Site Access Track

Current Conditions, Proposed Improvements

Guthries Lift Replacement DA

TABLE 3 – ACCESS CLARIFICATION

ACCESS_TRACK_ENTRY_DESIGN

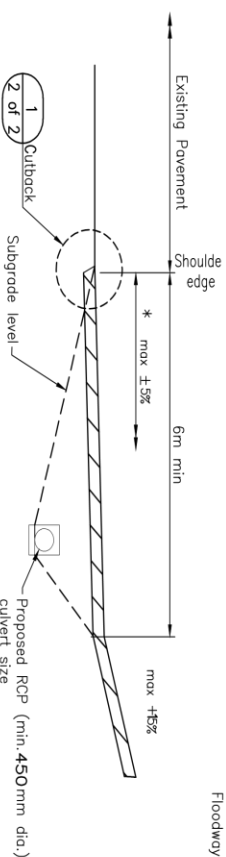
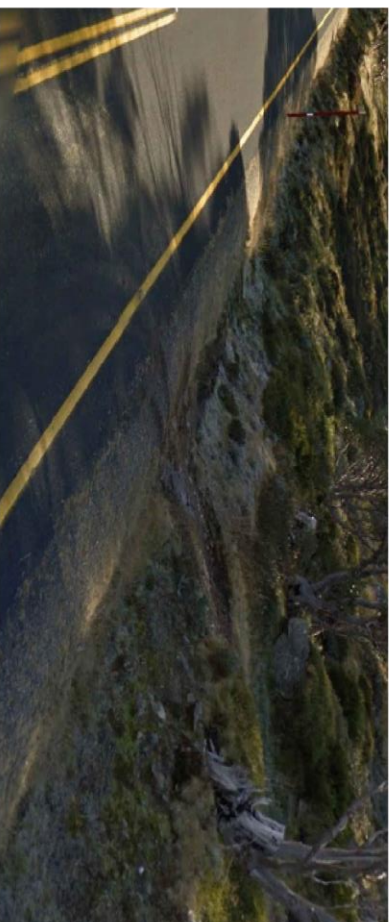
| | <p><u>Action:</u> For each of the photos below, CPSR to provide comments in relation to the Departments questions.</p> |
|--|--|
|  <p>The top photograph shows a paved road curving through a grassy area with several trees. A red circle highlights a specific tree branch near the road. The bottom photograph is a close-up of a cluster of trees with snow on the ground in the foreground.</p> | <ul style="list-style-type: none"> Can the Dopplemayr design on Plan 2020-15-C-023 be implemented without the need to remove or trim any of the trees close to the road? <p>Upon careful examination of Plan 2020-15-C-023 and the Doppelmayr design, we have determined that the implementation of the Doppelmayr design can proceed without the necessity of removing or trimming any of the trees situated near the road, except for one specific branch that has been identified in the picture. This particular branch will need to be removed to ensure the safe execution of the project</p> <ul style="list-style-type: none"> Is there adequate width between the trees and their canopy to all vehicles/machinery to pass by them without any damage? <p>Yes, there is enough width between the trees and their canopy to allow all vehicles and machinery, including a machine approximately 2.5 meters wide, to pass by them without any damage.</p> <ul style="list-style-type: none"> If any tree trimming or removal is proposed, please provide details. <p>We have identified potential limbs that may require trimming. These details, including the specific trees and limbs, will be provided to NPWS which we will submit for review and approval as part of the project implementation.</p> <ul style="list-style-type: none"> Access culvert is to be upgraded from the road as shown on drawing 2020-15-C-023. |

2020-15-C-024

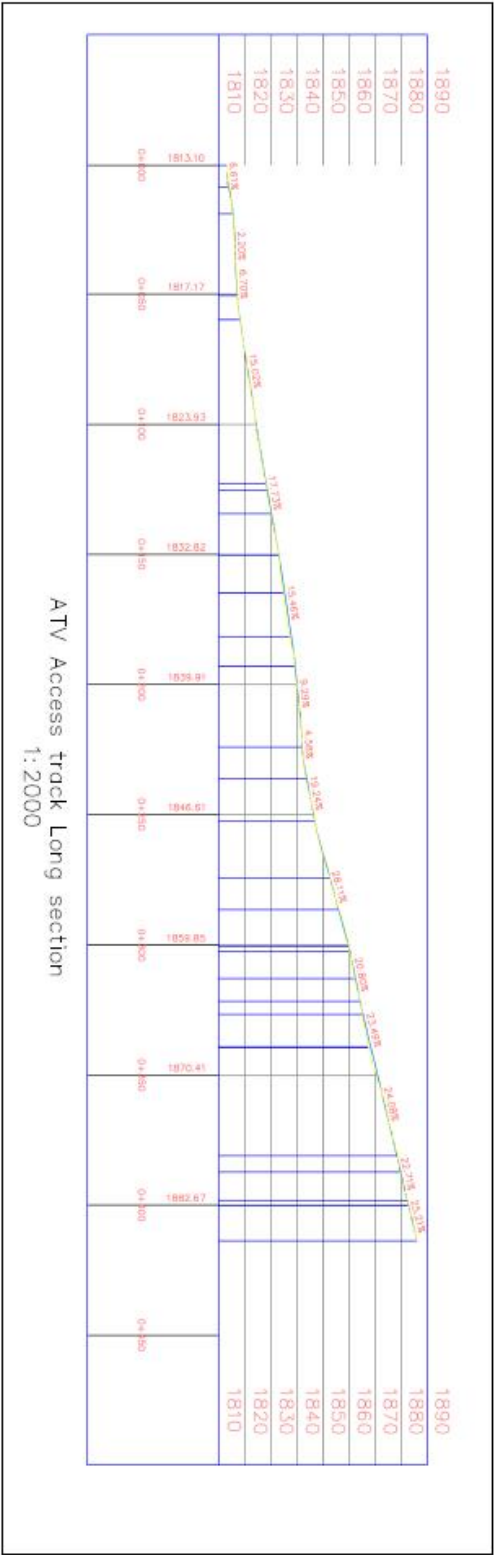
- Has your environmental consultant reviewed the Dopplemayr design on Plan 2020-15-C-024?

- Is this design appropriate for areas that are very wet and/or areas that may comprise endangered ecological communities?

- How will surface drainage continue to be managed at this site?

- How wide is the largest vehicle/machine that needs to pass by this site?

Yes, and has confirmed this does not impact the report.

The access track is to be constructed on 150mm of free-draining crushed rock placed on bidim to enable existing drainage to be maintained.

Whoa boys cross drains to be constructed at a maximum 50 m or where existing drainage paths exist.

Largest vehicle is a 13T excavator, regular passing by 1.6m ATV and positrack
